Project	<b>IEEE 802.16 Broadband Wireless Access Working Group</b> < <a href="http://ieee802.org/16">http://ieee802.org/16</a> >	
Title	<b>Renaming of handover and paging SAP primitives in section 14.5.9.2</b>	
Date Submitted	<b>2006-01-11</b>	
Source(s)	Ronald Mao Huawei Technologies Co., Ltd. 10180 Telesis Ct #365 San Diego, CA 92121	Voice: 001-858-882-0335 Fax: 001-858-882-0350 <a href="mailto:rmao@huawei.com">rmao@huawei.com</a>
Re:	Contribution on IEEE 802.16-2004/IEEE802.16g	
Abstract	This contribution proposes to update the primitive names in sections 14.5.9.2 of 16g r2.	
Purpose	Adoption	
Notice	This document has been prepared to assist IEEE 802.16. It is offered as a basis for discussion and is not binding on the contributing individual(s) or organization(s). The material in this document is subject to change in form and content after further study. The contributor(s) reserve(s) the right to add, amend or withdraw material contained herein.

The purpose of this contribution is to update M-SAP and C-SAP primitive names based on universal naming schema.

Figure 1 Paging Group Management Service Primitives

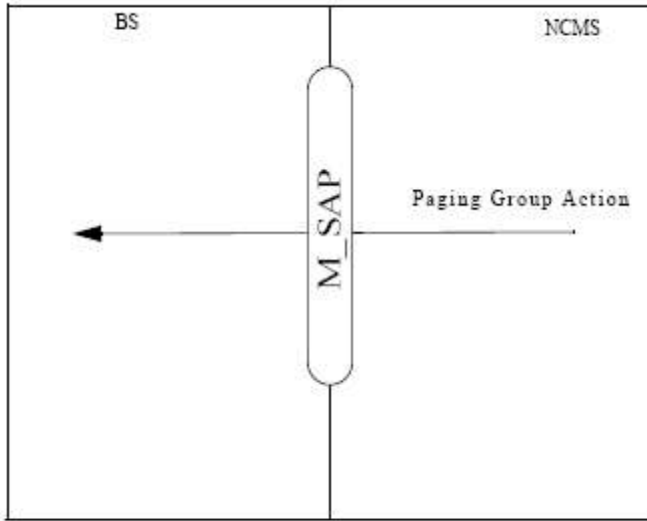
The location information of an idle MS is managed by the unit of Paging Group in Paging Service of an NCMS, and paging messages are sent to all the BSs within the called MS's Paging Group. The NCMS should divide the whole service area into multiple Paging Groups and notify this Paging Group information to all the BSs within the service area, where a BS may be a member of one or more Paging Groups. ~~In this contribution, we propose service primitive for Paging Group Action which is exchanged through Management Service Access Point (M-SAP) of Management Plane specified in IEEE 802.16g baseline document. Paging Group Action is performed by Paging Service of an NCMS. Service primitives for paging group management are exchanged through management service access point (M-SAP) of management plane, as shown in Fig. 12~~
